DOCUMENT CHANGE NOTICE (DCN)

DOCUMENT No. (DOC-REV-GP. ID)	TITLE	NEW REV.
D990143-B	Cavity Beam Dump Mounting Bracket Assembly	C

CAVITY BEAM DUMP
MOUNTING BRACKET ASSEMBLY

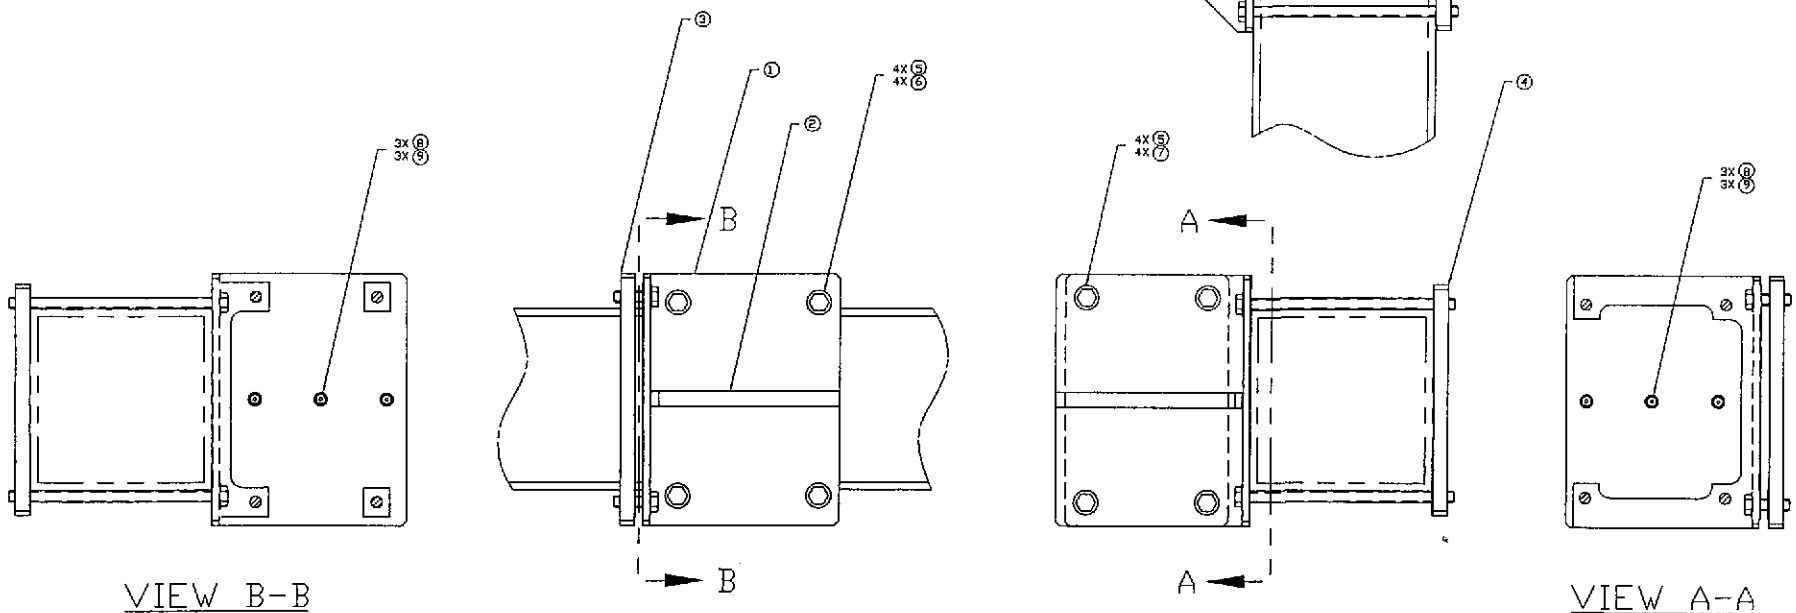
Changed Next Ass'y block entry from "D990145" to "D990230".
